**Project:** Southview Farmhouse, Trowbridge

**Subject:** Response to LLFA Comments

**Reference:** 19682-TUM-TN-XXX-0001

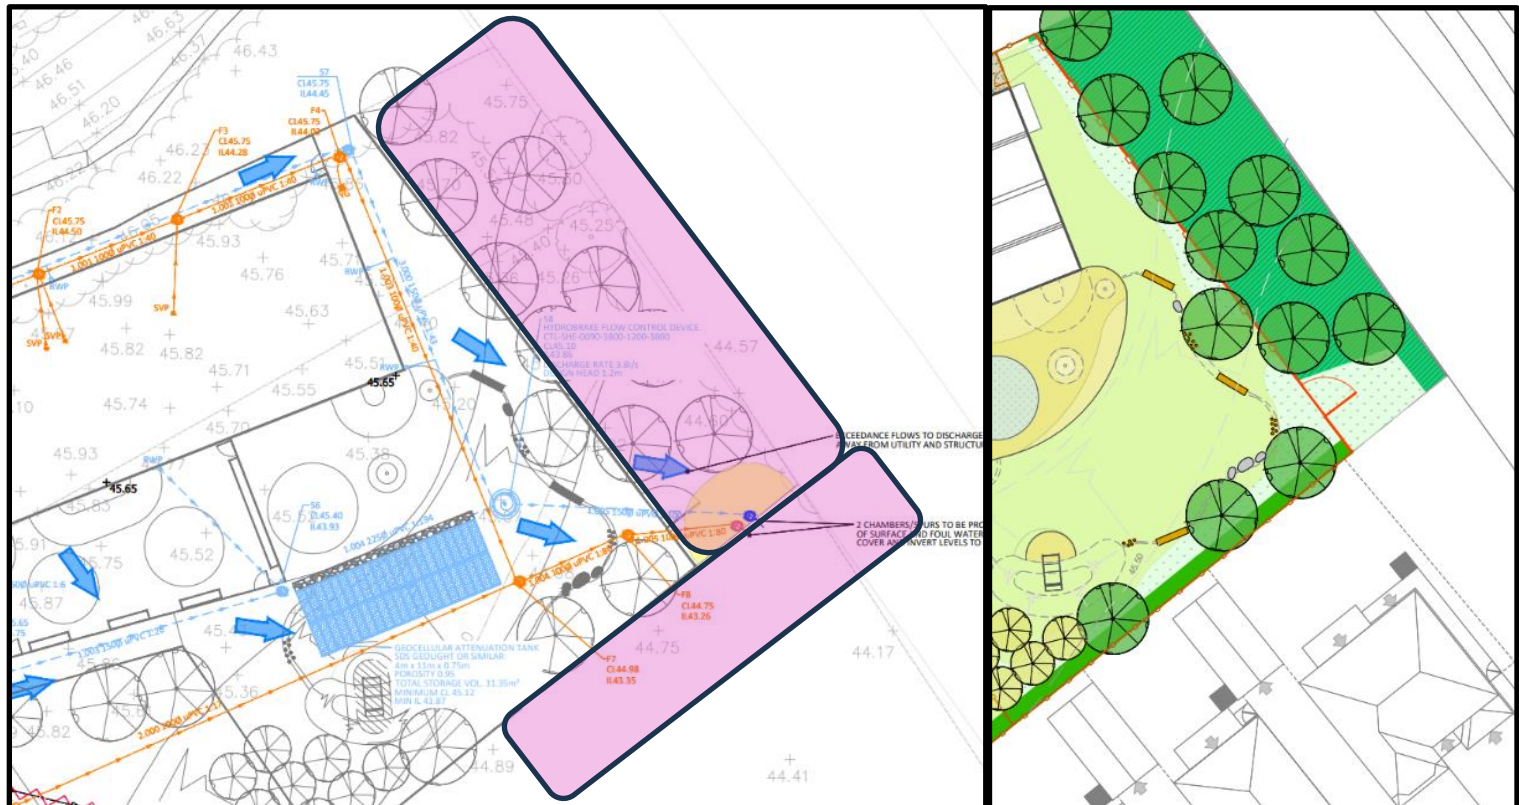
1. We note the applicant has stated in section 3.1 of the Drainage Strategy Statement that Redrow Housing have agreed to accept flows discharged at 3.8l/s. The applicant must provide a statement that demonstrates this agreement with Redrow Housing and acknowledges that any future drainage design and planning application on the Redrow Houses site will include a 3.8l/s discharge.
2. Post-development exceedance routing plans indicate that surface water exceedance flows are directed towards the future proposed development by Redrow Housing and the existing railway corridor.

The applicant is required to submit further details demonstrating how exceedance flows will be safely managed in the pink areas, demonstrating how exceedance will not increase flood risk to the future Redrow Housing development and the existing railway infrastructure. The LLFA would expect the applicant to manage flows onsite, without directing flows towards existing or proposed development.

| Wiltshire LLFA Comment                                                                                                                                                                                                                                                                                                                                                                                                                                                                                                                                                                                                | Tumu Response                                                                                                                                                                                                                                                                                                                                                                                                                                                                                                                                                                                                                                                                                                                                                                                                                                                                                                                                                                                                                                                                                                                                                                                                                     |
|-----------------------------------------------------------------------------------------------------------------------------------------------------------------------------------------------------------------------------------------------------------------------------------------------------------------------------------------------------------------------------------------------------------------------------------------------------------------------------------------------------------------------------------------------------------------------------------------------------------------------|-----------------------------------------------------------------------------------------------------------------------------------------------------------------------------------------------------------------------------------------------------------------------------------------------------------------------------------------------------------------------------------------------------------------------------------------------------------------------------------------------------------------------------------------------------------------------------------------------------------------------------------------------------------------------------------------------------------------------------------------------------------------------------------------------------------------------------------------------------------------------------------------------------------------------------------------------------------------------------------------------------------------------------------------------------------------------------------------------------------------------------------------------------------------------------------------------------------------------------------|
| <p>2. Post-development exceedance routing plans indicate that surface water exceedance flows are directed towards the future proposed development by Redrow Housing and the existing railway corridor. The applicant is required to submit further details demonstrating how exceedance flows will be safely managed in the pink areas, demonstrating how exceedance will not increase flood risk to the future Redrow Housing development and the existing railway infrastructure. The LLFA would expect the applicant to manage flows onsite, without directing flows towards existing or proposed development.</p> | <p>An extract from the Wiltshire LLFA comments dated 17/04/2026 has been reproduced below. The areas highlighted in pink have been labelled Area 1 and Area 2 for ease of reference.</p>  <p>Area 1 comprises an existing soft-landscaped area that will be enhanced through the planting of additional trees. No alterations to existing ground levels are proposed within Area 1; therefore, existing surface water flow routes will remain unchanged and continue to be governed by the site's existing topography. Surface water runoff from Area 1 will continue to leave the site at greenfield runoff rates. As these flows reflect existing greenfield conditions, there will be no increase in flood risk to either the railway infrastructure or the proposed Barratt Redrow development.</p> <p>Area 2 lies outside the application site boundary and falls within the Barratt Redrow development site. As this area is outside our client's control and is proposed to be redeveloped as part of the Barratt Redrow scheme, responsibility for the management of surface water runoff within Area 2 rests with Barratt Redrow.</p> |

| TITLE:   | TEMPORARY DRAINAGE               |

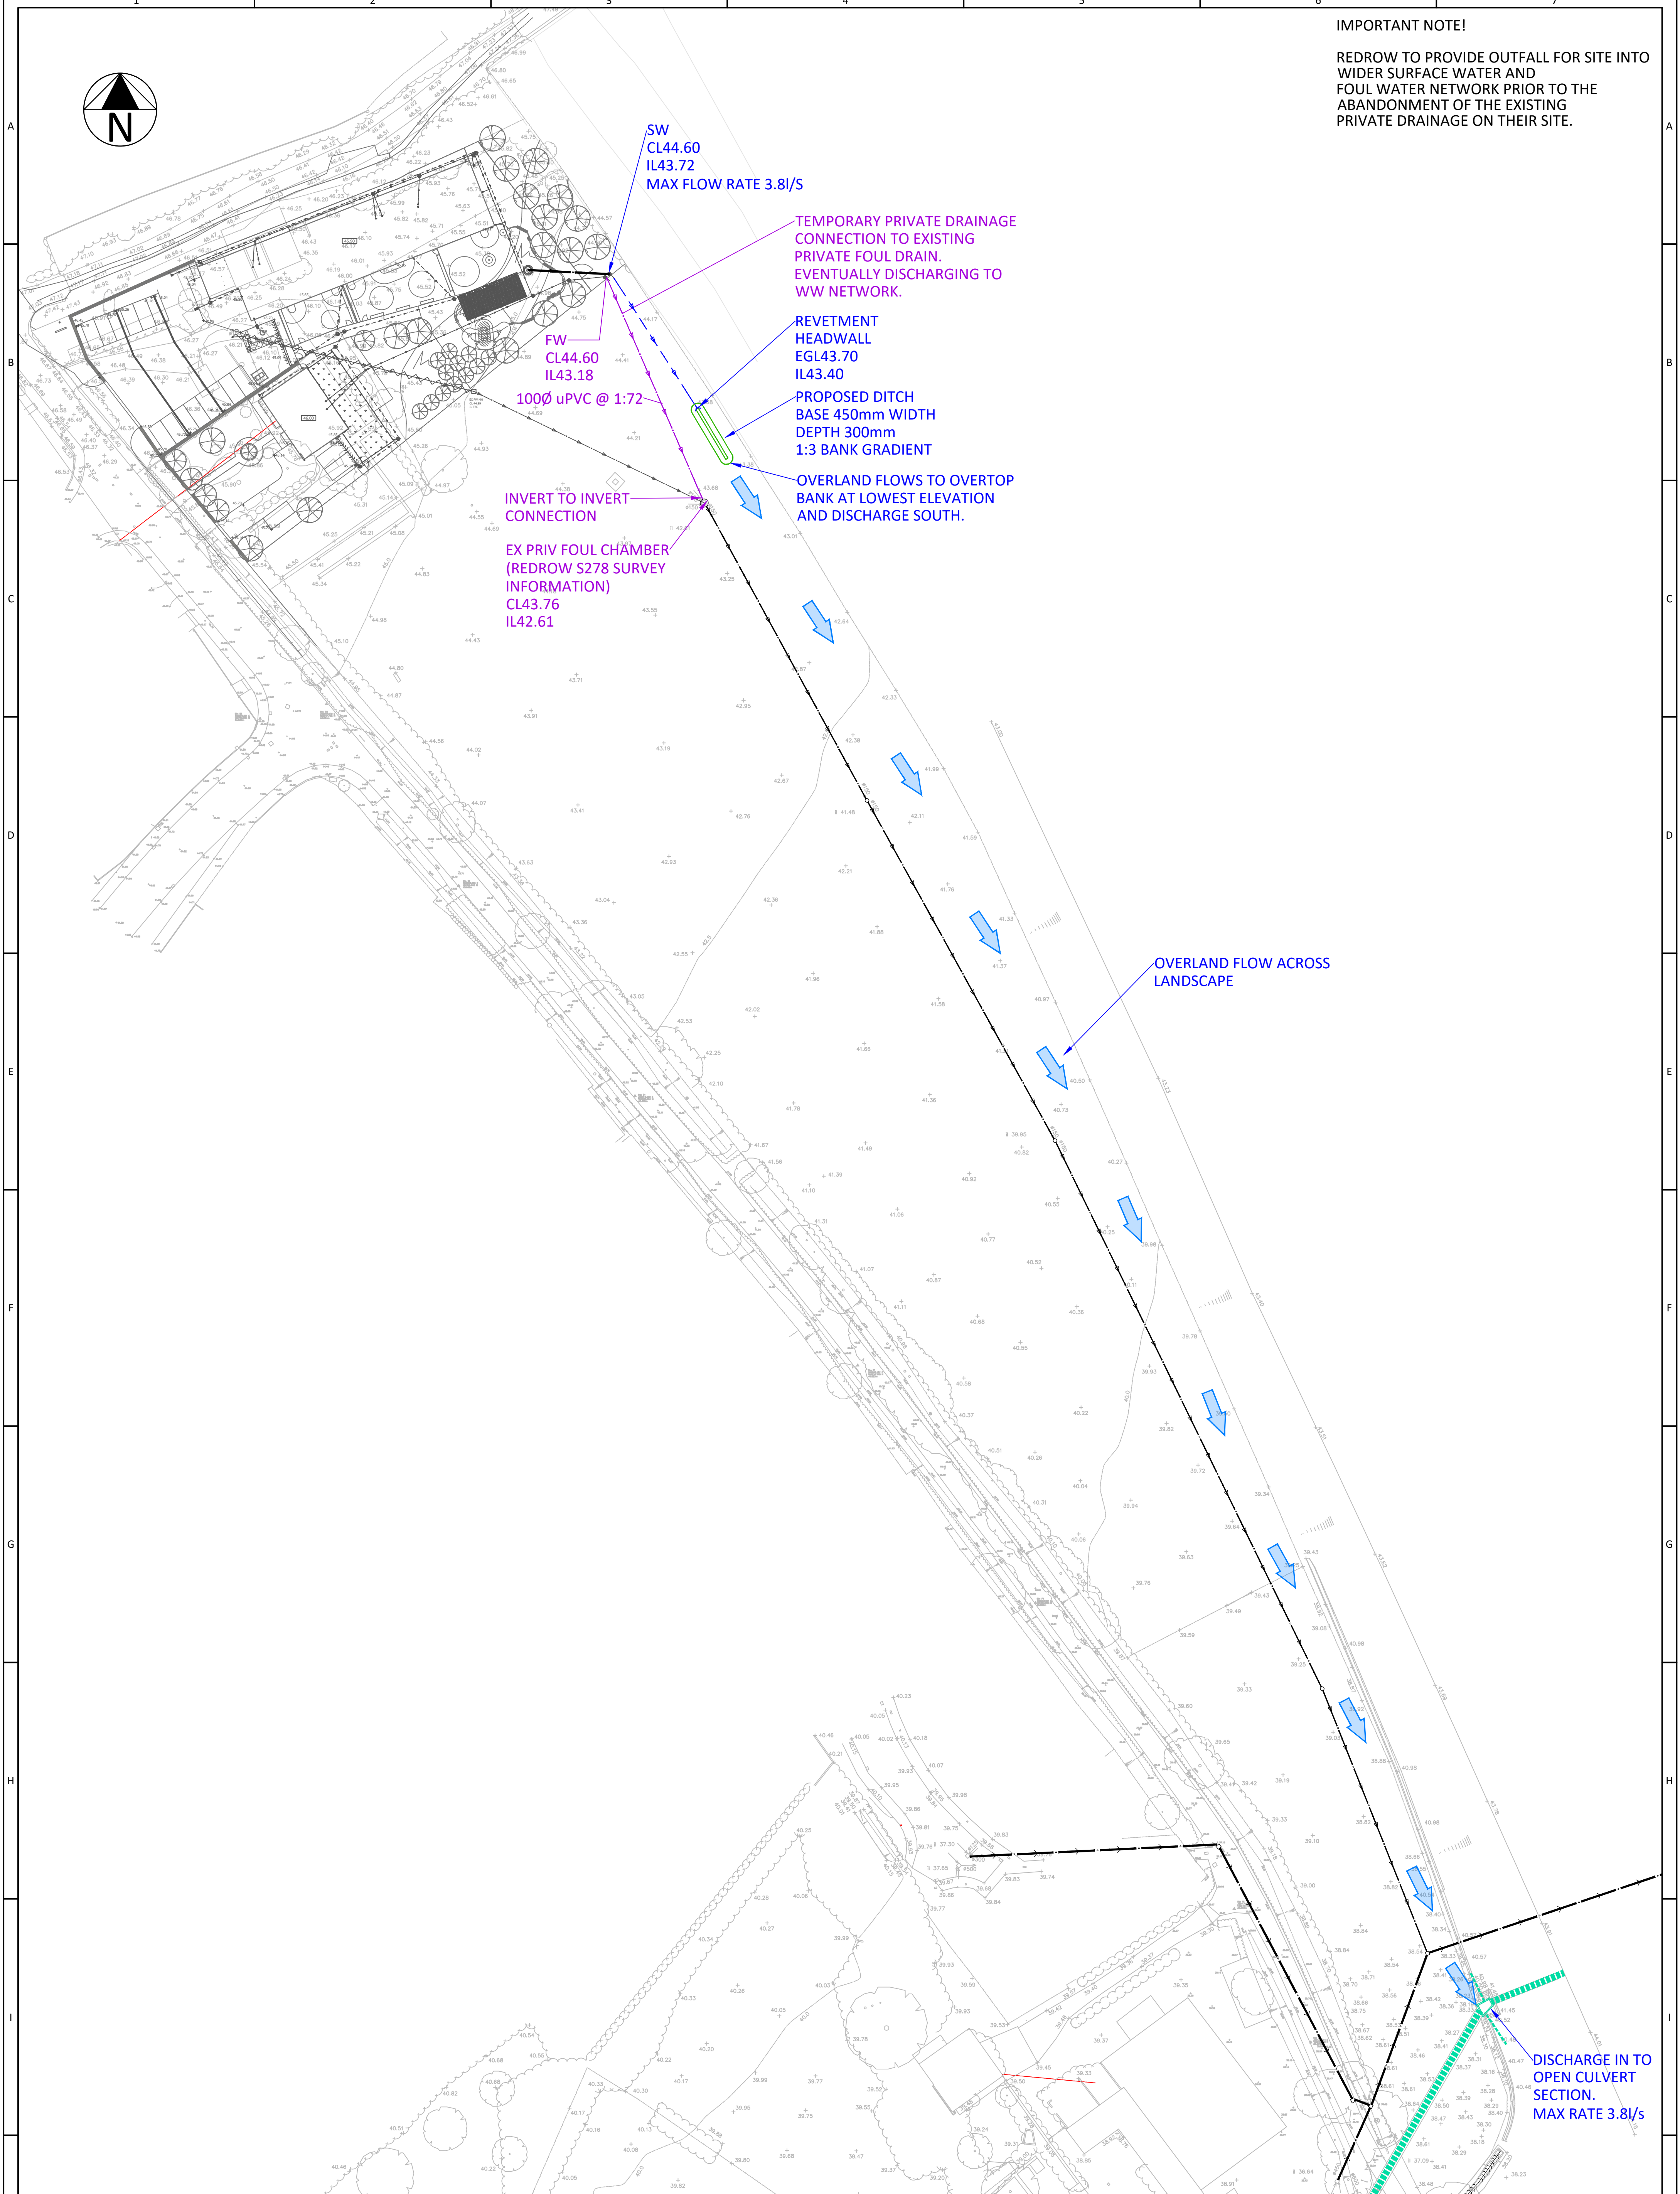
3. Currently it is unclear when the Redrow Housing drainage strategy will be operational and available to accept the 3.8l/s discharge. The applicant must provide a clear timeline for completion of the proposed drainage strategy development by Redrow Housing.

The applicant must demonstrate that the proposed development will not commence, or will not progress beyond agreed stages, until the Redrow Housing drainage network is in place and operational, or an alternative interim drainage solution has been approved in writing by the Local Planning Authority.

| Wiltshire LLFA Comment                                                                                                                                                                                                                                                                                                                                                                                                                                                                                                                                                                | Tumu Response                                                                                                                                                                                                                                                                                                                                                                                                                                                                                                                                                                                                                                                                                                                                                                                                                                                                                                                                                                                                                                                                                                            |
|---------------------------------------------------------------------------------------------------------------------------------------------------------------------------------------------------------------------------------------------------------------------------------------------------------------------------------------------------------------------------------------------------------------------------------------------------------------------------------------------------------------------------------------------------------------------------------------|--------------------------------------------------------------------------------------------------------------------------------------------------------------------------------------------------------------------------------------------------------------------------------------------------------------------------------------------------------------------------------------------------------------------------------------------------------------------------------------------------------------------------------------------------------------------------------------------------------------------------------------------------------------------------------------------------------------------------------------------------------------------------------------------------------------------------------------------------------------------------------------------------------------------------------------------------------------------------------------------------------------------------------------------------------------------------------------------------------------------------|
| <p>3. Currently it is unclear when the Redrow Housing drainage strategy will be operational and available to accept the 3.8l/s discharge. The applicant must provide a clear timeline for completion of the proposed drainage strategy development by Redrow Housing. The applicant must demonstrate that the proposed development will not commence, or will not progress beyond agreed stages, until the Redrow Housing drainage network is in place and operational, or an alternative interim drainage solution has been approved in writing by the Local Planning Authority.</p> | <p>The letter from Barratt Redrow included in Appendix B details the temporary drainage arrangements that will be available should the Southview Farm development be delivered in advance of the Barratt Redrow drainage infrastructure. The letter states:</p> <p><i>"Should the Southview Farm development be constructed ahead of our development, foul water from the site will temporarily connect to the existing foul water sewer currently serving Southview Farm, generally in accordance with drawing 19682-TUM-SK-XXX-0001 Temporary Drainage. We confirm that the existing sewer will not be removed until a replacement connection for Southview Farm has been provided. Until our permanent drainage design is implemented, attenuated surface water runoff from Southview Farm will discharge via a combination of temporary ditch conveyance and overland flow routes to the culvert crossing beneath the railway line within our site, as shown on the above-referenced drawing."</i></p> <p>Drawing No. 19682-TUM-SK-XXX-0001 Temporary Drainage is included in Appendix B of this Technical Note.</p> |

Should the Southview Farm development be constructed ahead of our development, foul water from the site will temporarily connect to the existing foul water pipe currently serving the Southview Farm site, generally in accordance the proposals set out on sketch drawing; 19682-TUM-SK-XXX-0001 Temporary Drainage. We confirm that the existing sewer will not be demolished until a replacement connection for Southview Farm has been provided.

Until our permanent drainage design is implemented attenuated surface water from Southview Farm will discharge via a combination of temporary ditch conveyance and overland flow routes to the culvert crossing beneath the railway line within our site, as shown on the above referenced drawing.

REDROW TO PROVIDE OUTFALL FOR SITE INTO  
WIDER SURFACE WATER AND  
FOUL WATER NETWORK PRIOR TO THE  
ABANDONMENT OF THE EXISTING  
PRIVATE DRAINAGE ON THEIR SITE.

DISCHARGE IN TO  
OPEN CULVERT  
SECTION.  
MAX RATE 3.8l/s
